MEMO: CONDITIONAL USE PERMIT (CUP) - FOR LETURNO-HWY 126

| AGENCY FILE NO.: | PC 24 01 CUP 01 (PC 23 27 CUP 04) |

The subject property is 1.15 vacant acres zoned commercial located on Highway 126 in the south easter aera of Florence along the Siuslaw River. The applicant seeks a Conditional Use Permit to allow residential development of 10 attached single unit dwellings in the Commercial District as regulated by Florence City Code Title 10, Chapter 15, located at 5439 Hwy 126 as shown on Assessor's Map # 18-12-26-31, Tax Lot 02300.

This narrative addresses August 27, 2024, draft Findings of Fact Notice, Exhibit "A", September 12, 2024, PC 24 01 CUP – Siuslaw Bay View Zoom Meeting, October 7, 2024, email and attached notes from October 4, 2024, meeting with city staff and DLCD, and related correspondence. Combined with previous submittals, the applicant has addressed all questions raised by city staff and Florence City Code related to this site.

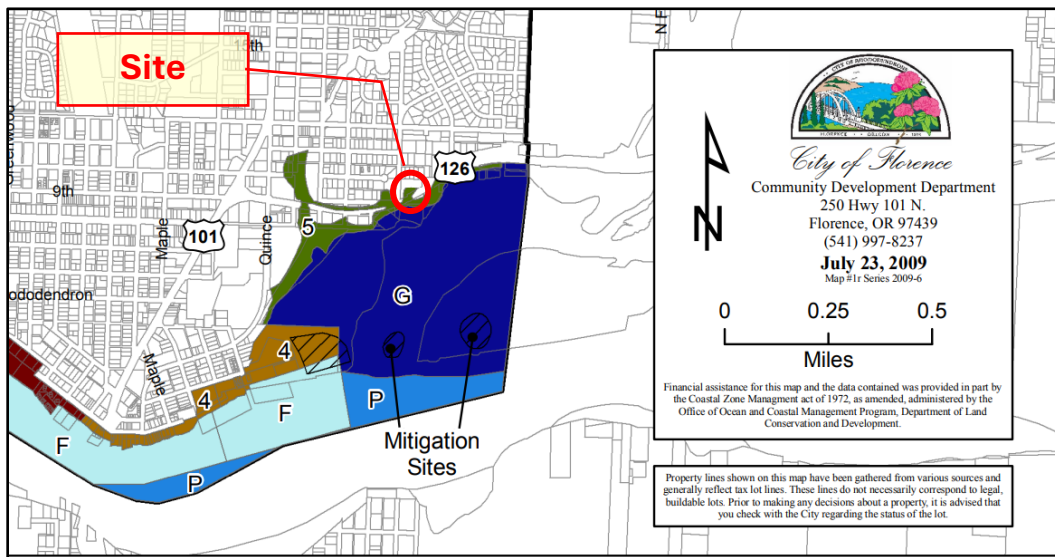
“Floodplain/Floodway - The project site is outside of the regulatory flood plain”

“Estuary and Shoreland Management Unit Overlays - Both the Natural Estuary (NE) and the Natural Conservation (NRC.) Shoreland management units apply to the portion of the project site that is within the NRC per FCC 10-19-10-A. ... Per the Comprehensive Plan this is “a 50-foot wide strip of land measured from the mean high tide line .” This is measured from the base flood elevation of 14 feet as seen on the 2020 survey.”

The /NRC zone is governed by FDC 10-19-10. The general location of the /NRC boundary is displayed on Map 17-1: Estuary & Coastal Shorelands Management Units in the Florence UGB.¹⁶ Map17-1 is an adopted Comprehensive Plan document that shows the general location of all estuaries and coastal shoreland management units in the Florence UGB. Please see snip below from Map 17-1, highlighting the site.

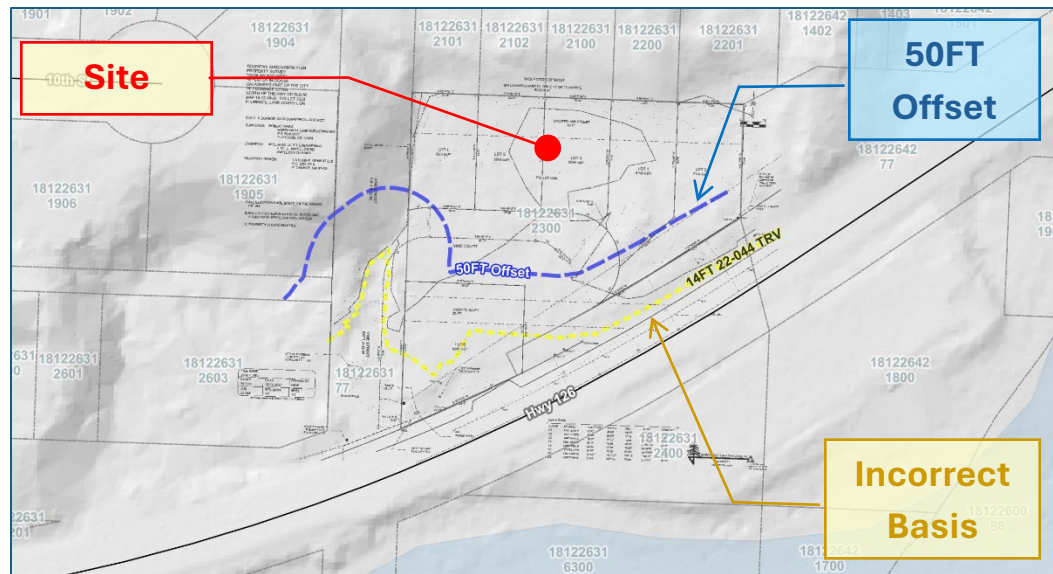
Attempting to follow FCC 10-19-10: G.1, the city provided a 2022 survey (22-044-TRV) of the 14' base flood elevation (BFE)¹⁷ from which a 50ft buffer was proposed to determine the location of the /NRC zone. The survey boundary and the related setback are shown in the map below, where proposed /NRC extent is displayed in blue and the 14FT base flood elevation in yellow.

Please note the difference in shape and location compared to the LC GIS layer and Map17-1. The city initially used the incorrect basis for the 50ft buffer and as a result this is an incorrect application of /NRC zone FCC 10-19-10: G.1.

However, the 14ft BFE is not the “mean high tide.” Therefore, the setback shown in the map above is incorrect. The applicant reached out to NOAA for guidance and data on the location of the “mean high tide.” NOAA clarified that “mean high tide” and “mean high water” are the same,

Map 10.A - Incorrect /NRC Buffer from 14FT BFE

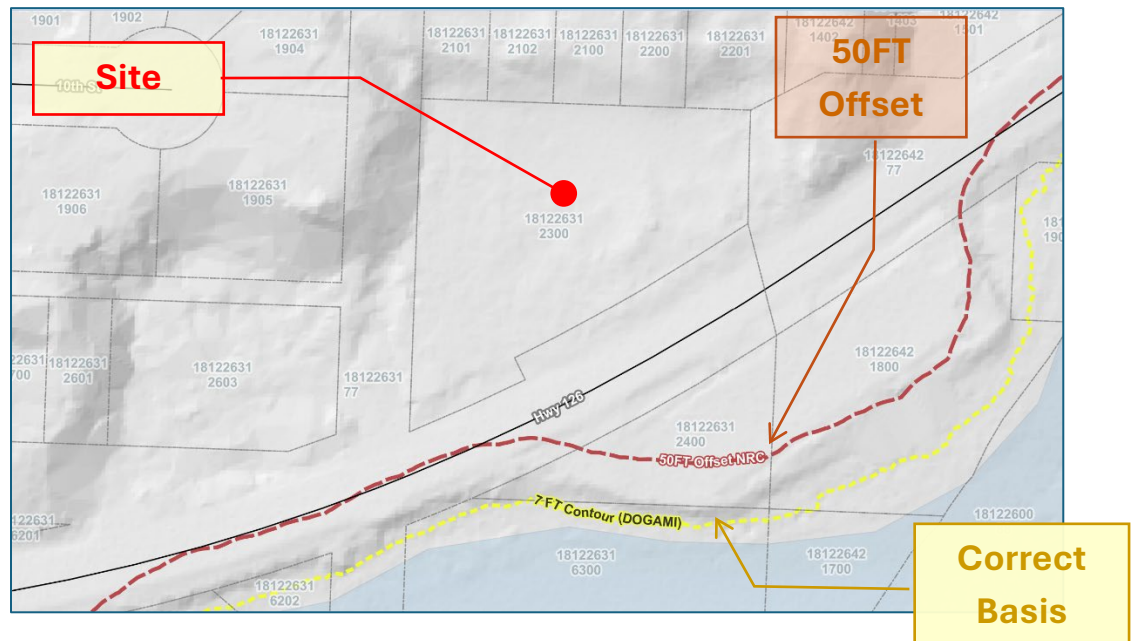
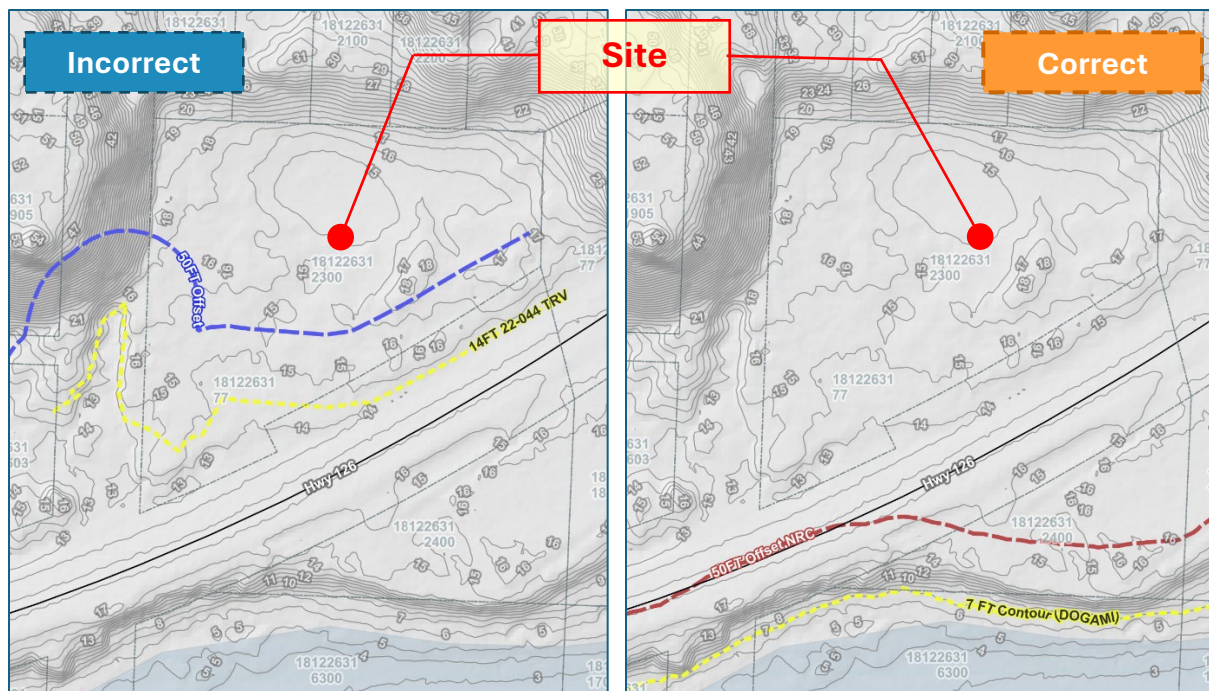
- FEMA 14 FT Base Flood Elevation with 50 FT - **incorrectly** identifies /NRC
- NOAA 6.56 FT²⁰ Mean High Water (Mean High Tide) with 50 FT - **correctly** identifies /NRC

Map 9.B – Correct /NRC Buffer from MHW (Mean High Tide)

Map 1 - Snip from attached Utility Plan showing location of proposed Street Light

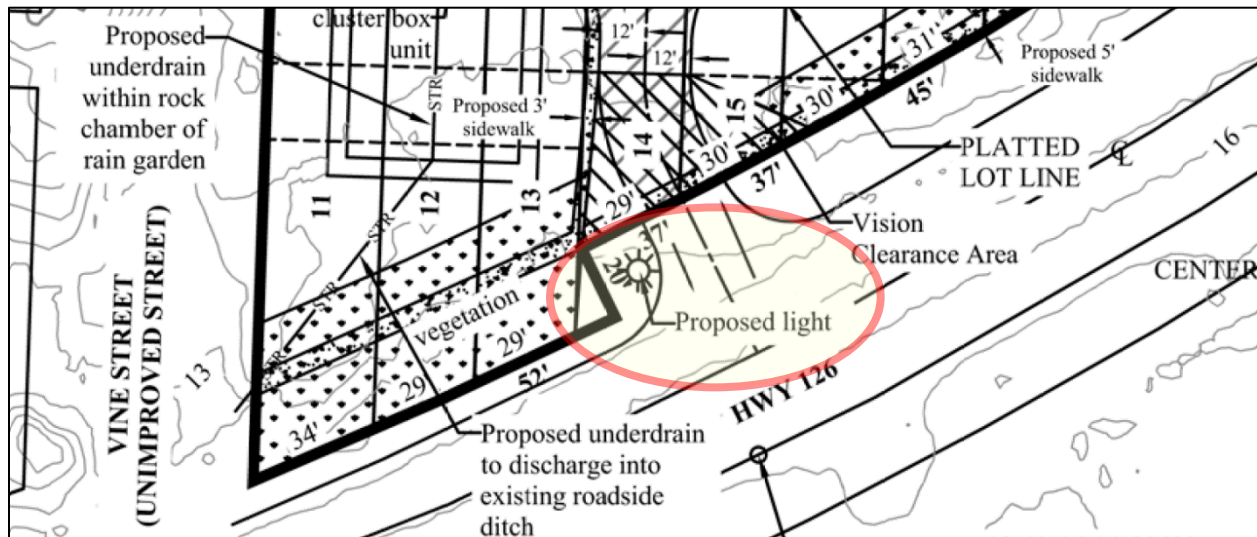
Street lights are required in all developments within the City for public safety. A street light where the shared driveway intersect the Hwy 126 ROW will be required.

- **Provide the street light proposed location**

Response: Applicant proposes a streetlight at the entry to the as illustrated in the utility plans. Please see attached plans and snip below.
